ATTACHMENT No. 2

PROPOSED
TECHNICAL SPECIFICATIONS
CHANGES

8209080361 820831
PDR ADOCK 05000219
P PDR

FIGURE 3.10-1
MAXIMUM ALLOWABLE AVERAGE PLANAR
LINEAR HEAT GENERATION RATE
(FIVE LOOP OPERATION)

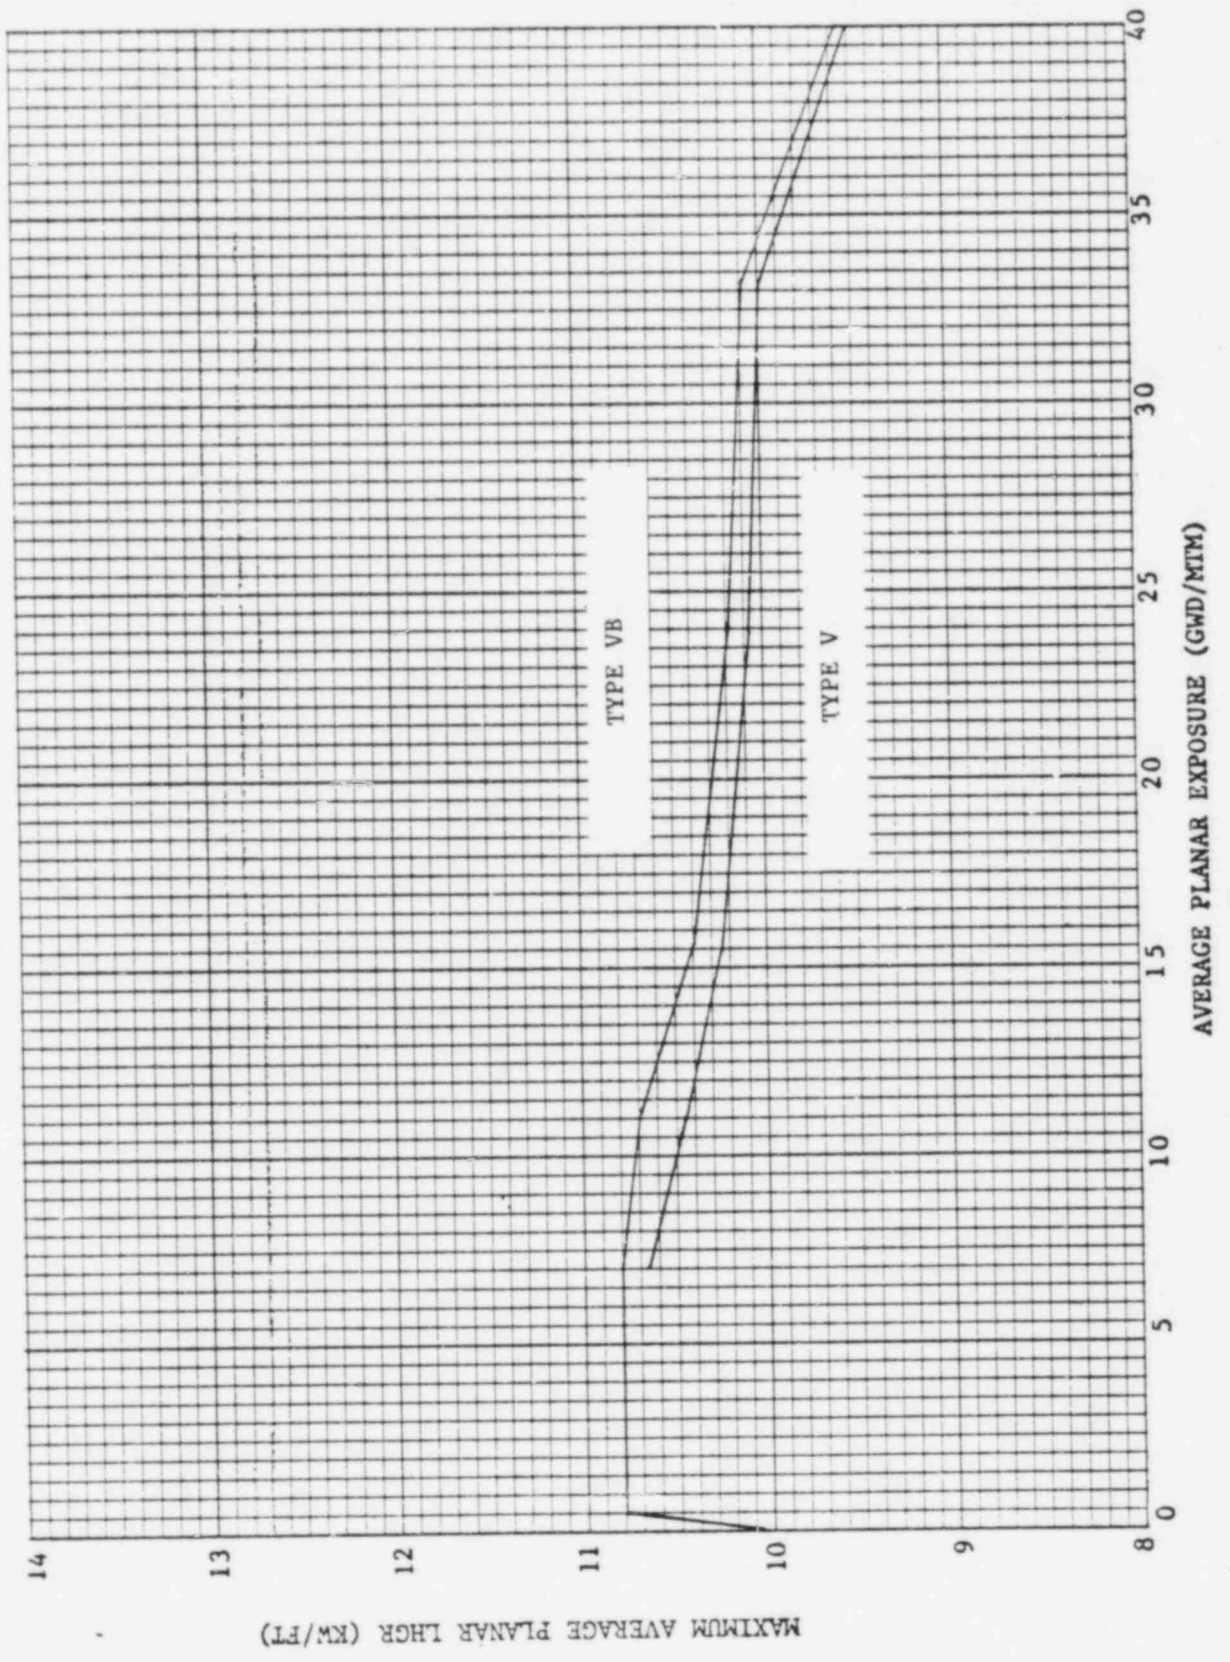
The product of the maximum average planar LHGR (MAPLHGR) limit shown in Figures 3.10-1 (for 5-loop operation) and 3.10-2 (for 4-loop operation) and the axial MAPLHGR multiplier in Figure 3.10-3.

The maximum average planar LHGR limits of fuel types V and VB are shown in Figure 3.10-1 for five loop operation and in Figure 3.10-2 for four loop operation, and are the result of LOCA analyses performed by Exxon Nuclear Company utilizing an evaluation model developed by Exxon Nuclear Company in compliance with Appendix K to 10 CFR 50 (1). Operation is permitted with the four-loop limits of Figure 3.10-2 provided the fifth loop has its discharge valve closed and its bypass and suction valves open. In addition, the maximum average planar LHGR limits shown in Figures 3.10-1 and 3.10-2 for Type V and VB fuel were analyzed with 100% of the spray cooling coefficients specified in Appendix K to 10 CFR Part 50 for 7 x 7 fuel. These spray heat transfer coefficients were justified in the ENC Spray Cooling Heat Transfer Test Program (2).

FIGURE 3.10-4
MAXIMUM ALLOWABLE AVERAGE PLANAR
LINEAR HEAT GENERATION RATE
(FIVE LOOP OPERATION)

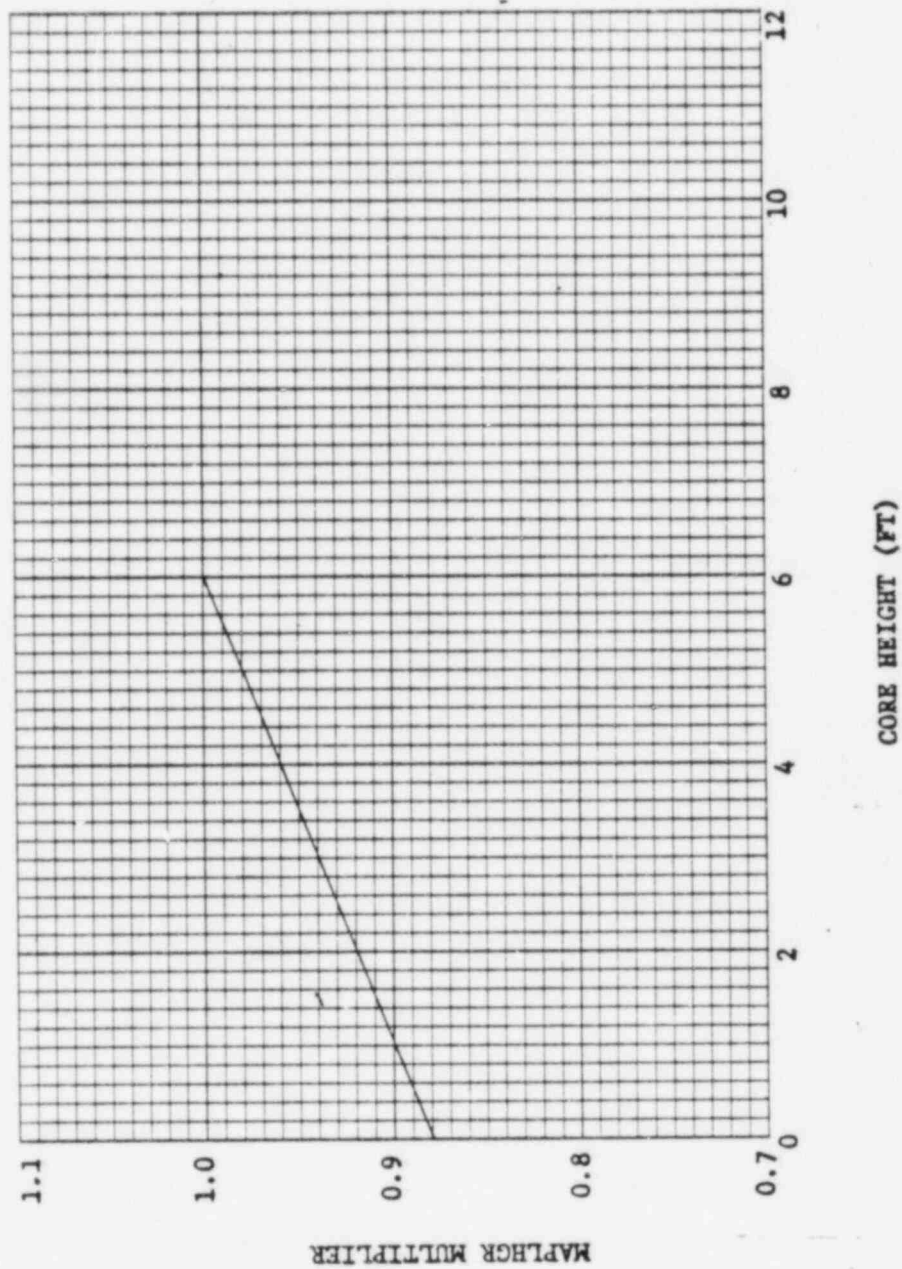
The maximum average planar LHGR (MAPLHGR) limit shown in Figure 3.10-4 (for 5-loop operation) and 3.10-5 (for 4-loop operation).

The maximum average planar LHGR limits of fuel type P8x8R are shown in Figure 3.10-4 for five loop operation and in Figure 3.10-5 for four loop operation, and are based on calculations employing the models described in Reference 3.

FIGURE 3.10-6 FLOW FACTOR, K_f

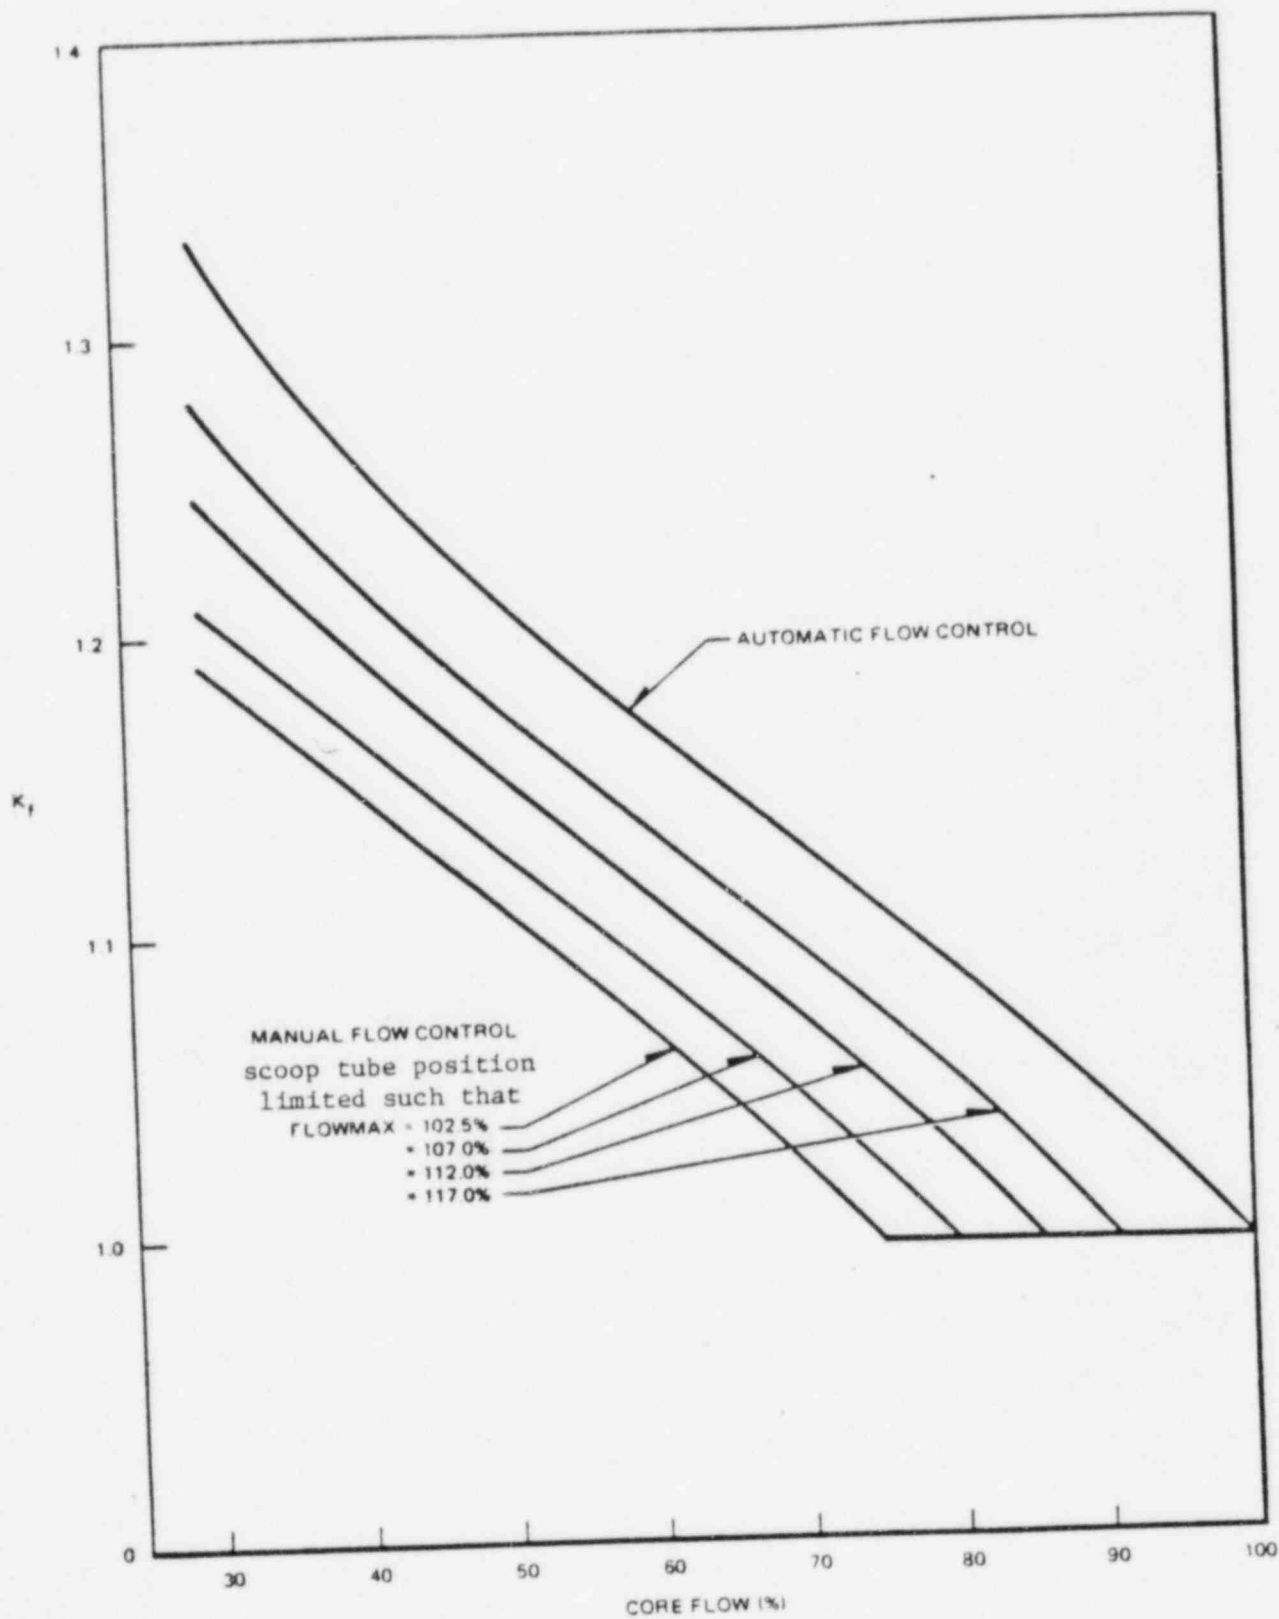
For core flows other than rated, the nominal value for MCPR shall be increased by a factor of k_f , where k_f is as shown in Figure 3.10-6.

The K_f factor curves shown in Figure 3.10-6 were developed generically using the flow control line corresponding to rated thermal power at rated core flow and are applicable to all BWR/2, BWR/3 and BWR/4 reactors. For the manual flow control mode, the K_f factors were calculated such that at the maximum flow state (as limited by the pump scoop tube set point) and the corresponding core power (along the rated flow control line), the limiting bundle's relative power was adjusted until the MCPR was slightly above the Safety Limit. Using this relative bundle power, the MCPR's were calculated at different points along the rated flow control line corresponding to different core flows. The ratio of the MCPR calculated at a given point of core flow, divided by the operating limit MCPR determines the value of K_f .
